VIRGINIA ELECTRIC AND POWER COMPANY
RICHMOND, VIRGINIA 23261

VIRGINIA ELECTRIC AND POWER COMPANY
SURRY POWER STATION UNITS NO. 1 AND 2
PROPOSED TECHNICAL SPECIFICATIONS CHANGE
FOR INCREASED ENRICHMENT OF RELOAD FUEL

Attachment 1

Discussion of Change

Figure 7
Surry Spent Fuel Pool
Region 1 Burnup Credit

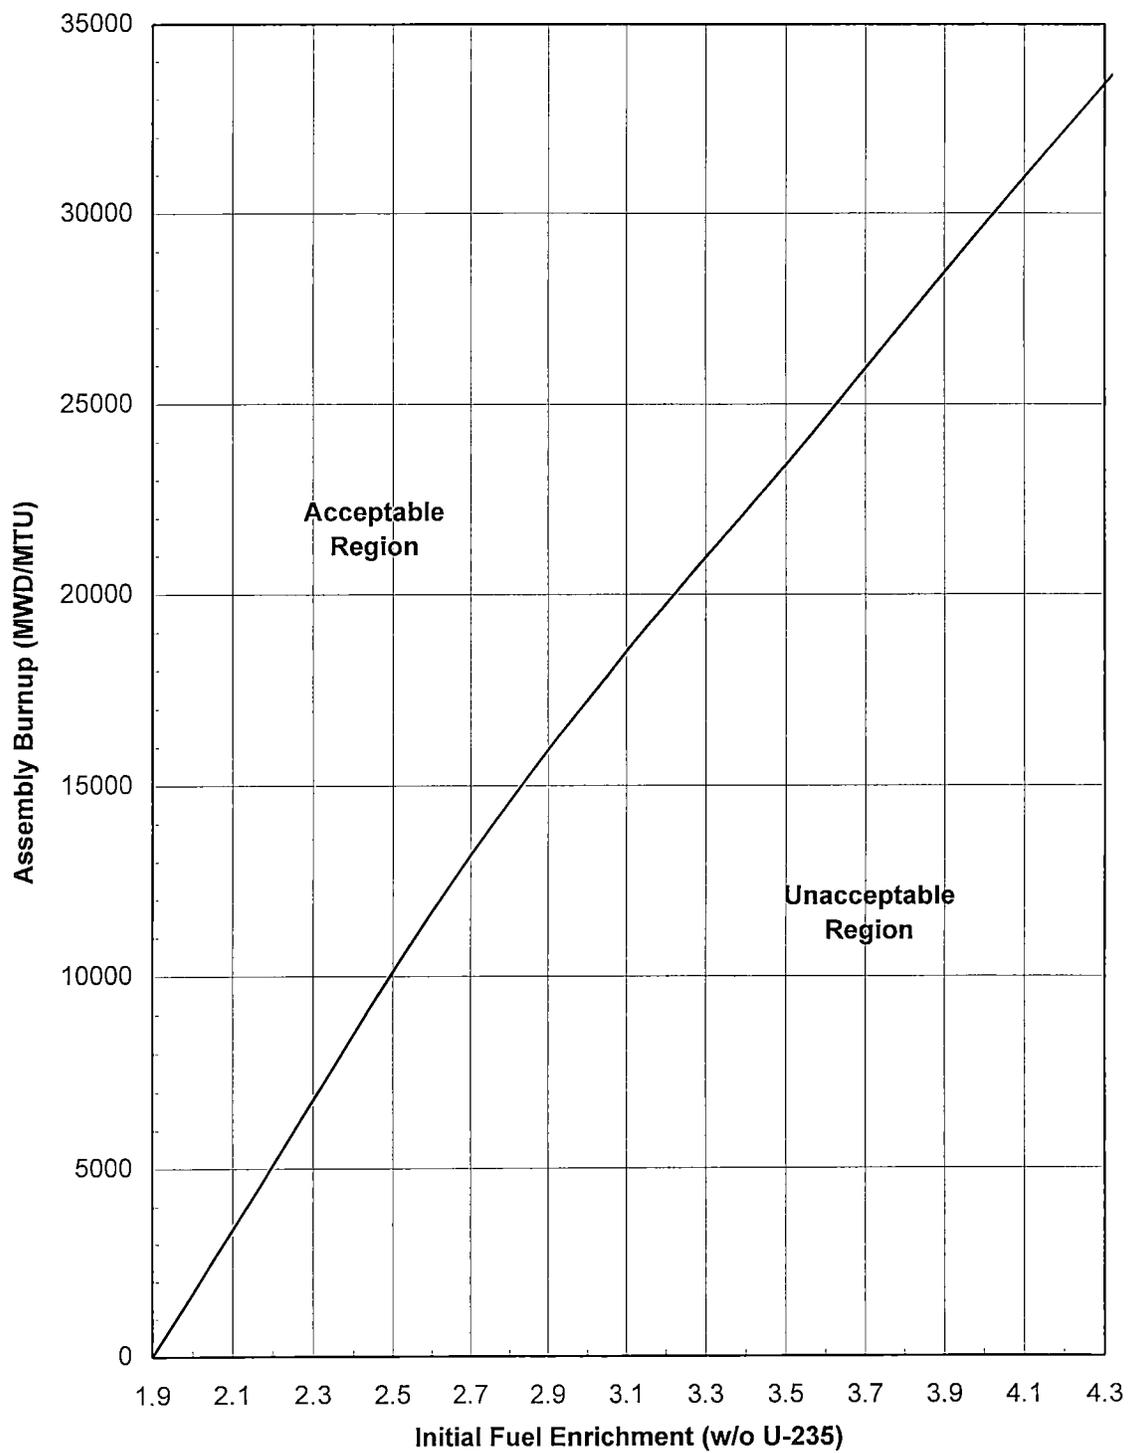
As discussed in Section 3 above, with the increase of the maximum initial fuel enrichment to 4.3 weight percent U^{235} , Figure 5.4-1 of the Technical Specifications will be modified as shown in Figure 7 to ensure that criticality limits are satisfied for placement of the higher enrichment fuel

Figure 7 shows the results of the burnup credit reactivity equivalencing calculations. Use of fuel with a burnup and enrichment combination which falls above the Figure 7 curve in Region 1 of the Surry spent fuel pool would ensure that the spent fuel pool K-effective remains less than or equal to 0.95 during a fuel storage cask handling accident. Therefore, fuel which falls within the acceptable area of Figure 7 is acceptable for storage in Region 1 of the Surry spent fuel storage pool.
